DISPUTE REVIEW BOARD RECOMMENDATION

RE: Contract T2350, Fin. Project Number 212949-8-52-01
I-75 (SR 93) Operational Improvements at SR 26

Subject: Hearing Dated March 9, 2012
Disputes Review Board Recommendation

Issue: Entitlement to Additional Compensation Resulting from Differing Site Condition with Regard to the Existing Soil Conditions at Pond B-4

Figure 1 Excerpt from plan sheet 47

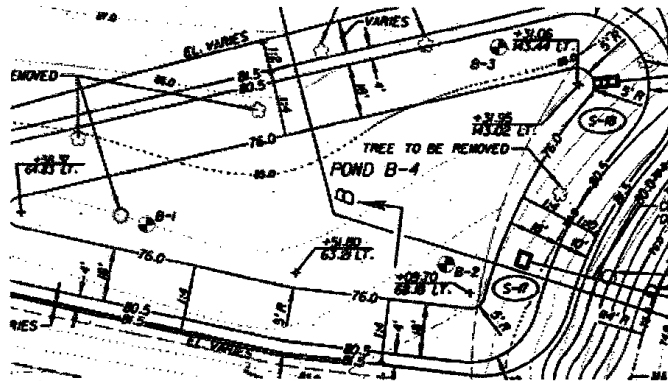
Plan Sheet 47 shows a plan view of Pond B-4, on which three clearly labeled borings are indicated: B-1, B-2, and B-3, see Figure 1.

1. Plan Sheet 47 includes boring location symbols labeled as B-1, B-2 and B-3. The boring locations are generally at the corners of pond B-4. There is no information on Sheet 47 indicating that the boring data has not been provided in the construction plans.

The DRB recognizes the fact that an examination of the boring locations given in the Roadway Soil Survey data would call into question the correlation of pond B-4 borings B-1, B-2 and B-3 with the soil data provided. However, within the context of preparing a cost estimate for bid, the DRB believes that a reasonable contractor, unaware of the policy to not provide pond soil data, would accept the soil data by boring number without plotting the location information. The FDOT did not utilize several of the options available to them to improve the clarity of the project plans including removing the boring symbols from sheet 47 or including a plan note clarifying that the boring data was not provided. Perhaps the best option would have been to include the actual boring data from the pond B-4 borings which the FDOT possessed.

Accordingly, it is the DRB's recommendation that DAB is entitled to compensation for a differing site condition. More specifically entitlement is limited to the boring data's indication of the existence of select material at the boring locations, where no select material was found. However, variations in soil conditions between borings is possible, consequently the determination of indicated quantity remains an issue to be determined by the parties. Additionally, the DRB notes that the pond B-4 cross sections clearly indicate over excavation. The original work would have required the excavation of the upper materials regardless of their classification.

Figure 2 Excerpt from plan sheet 50

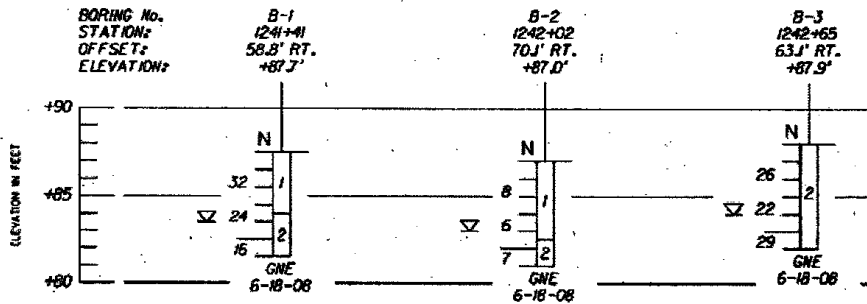
These borings correlate with borings B-1, B-2, and B-3 in the Roadway Soils Survey on Plan Sheet 50. These borings indicate that the material in Pond B-4 is select in nature being primarily A-3 sand with a thin layer of non-plastic A-2-4 below. This soils data is shown in Figure 2.

2. The Roadway Soil Survey includes boring data for borings B-1, B-2 and B-3. Stratum 1 material (A-3 soil) is indicated to be present at boring locations B-1 and B-2.

3. The Plan Sheet 49 contains the following note pertaining to the Roadway Soil Survey: "4. SOIL ANALYSIS INCLUDES DATA FROM ROADWAY AREAS ONLY"
4. The soil boring data contained in the Roadway Soil Survey for borings B-1, B-2 and B-3 includes the roadway station and offset data for each boring. The location information does not correspond to the pond B-4 location.
